## **HUFF PLACE SUBDIVISION, RESUBDIVISION OF LOT 1**

Engineering Comments: FINAL PLAT COMMENTS (should be addressed prior to submitting the FINAL PLAT for review and/or signature by the City Engineer):

APPLICATION NUMBER 10 DATE October 1, 2020

# DETAIL SITE PLAN

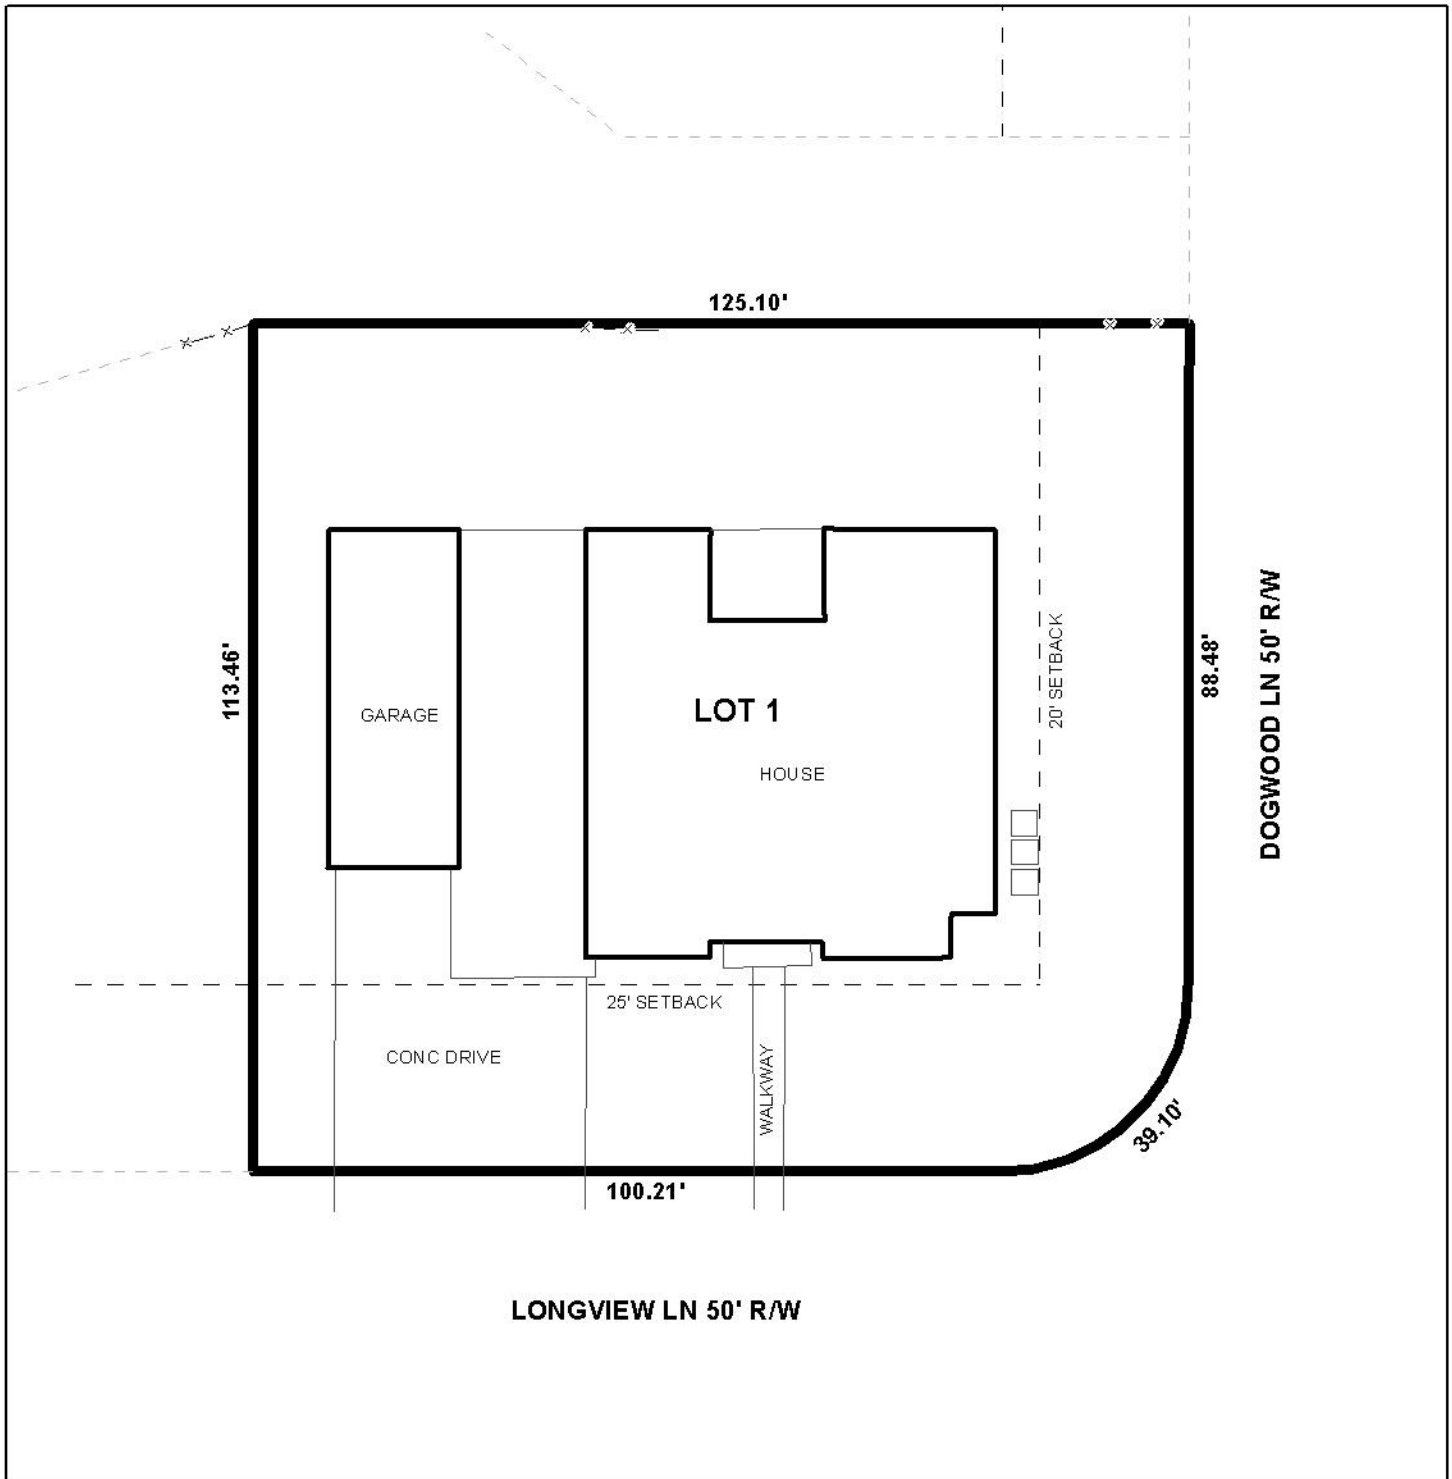
The proposed lot has frontage on both Longview Lane and Dogwood Lane. Both are minor streets without curb and gutter typically requiring a 60-foot right-of-way per the Subdivision Regulations. The preliminary plat illustrates a 50-foot right-of-way for both streets. It is important to note that

the subject site was included in the Huff Place Subdivision, recorded in 1979, of which the Final Plat illustrates a right-of-way width of 33-feet for both Longview Lane and Dogwood Lane, with dedication to provide 25-feet from the centerline of both street frontages. As such, if approved, a waiver from Section V.B.14. of the Subdivision Regulations may be appropriate.

As illustrated, the preliminary plat depicts a compliant 25-foot minimum building setback fronting Longview Lane and a 20-foot minimum building setback fronting Dogwood Lane. Section V.D.9. of the Subdivision Regulations requires a 25-foot minimum front yard setback for all frontages. However, it is important to note that as the subject site is a corner lot, Section 64-4.D.3. of the Zoning Ordinance does allow for a minimum 20-foot side yard side street setback for corner building sites. If approved, a waiver from Section V.D.9. of the Subdivision Regulations would be in order.

The proposed lot meets the minimum size requirements of the Subdivision Regulations and as such, the lot size label in both square feet and acres should be retained on the Final Plat or a table should be furnished on the Final Plat providing the same information.

As a means of access management, a note containing the Traffic Engineering comments should be placed on the Final Plat.

Based upon the preceding, and with waivers of Sections V.B.14. and V.D.9., the plat meets the minimum requirements of the Subdivision Regulations and is recommended for Tentative Approval, subject to the following conditions:

- 1) Retention of the lot size label in both square feet and acres on the Final Plat or the furnishing of a table on the Final Plat providing the same information;
